FIRE SAFETY INSPECTION REPORT

PIMKIE APPARELS LTD.

ACCORD
on Fire and Building Safety in Bangladesh

May 25, 2014

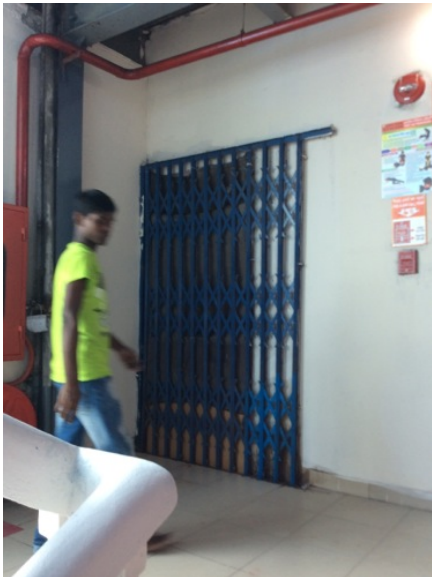
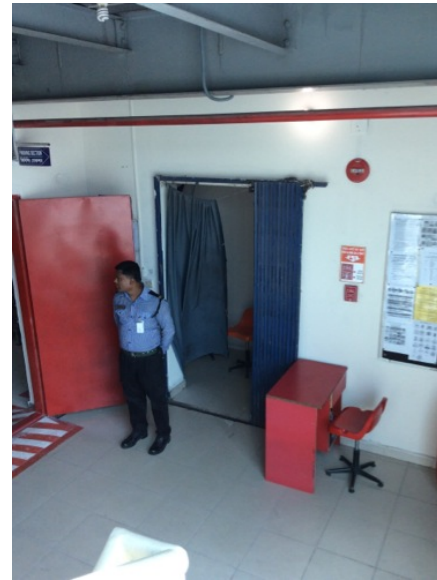
F-2	Fire Rated Construction	The boiler room is not separated by fire-rated construction from egress path (openings, non-rated doors, penetrations).	Separate the boiler room by a minimum 2-hr fire-rated construction. Seal and/or protected all openings to maintain the required fire separations	Within 3 months

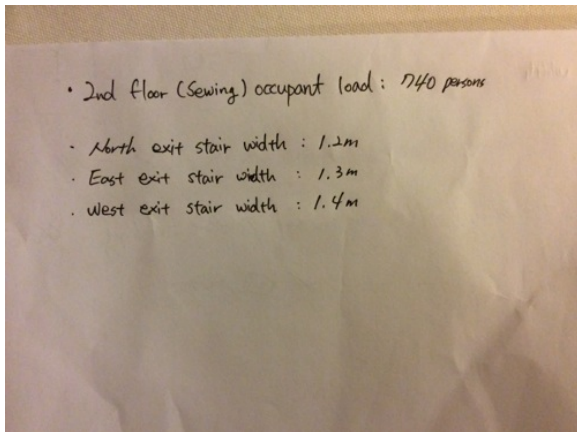
F-6	Fire Rated Construction	The exit stairs are not separated from work areas on each floor by fire-rated construction.	Provide fire-rated construction for all unprotected openings to separate the exit stairwells from work areas on all floor levels.	Within 3 months
-----	-------------------------	---	---	-----------------
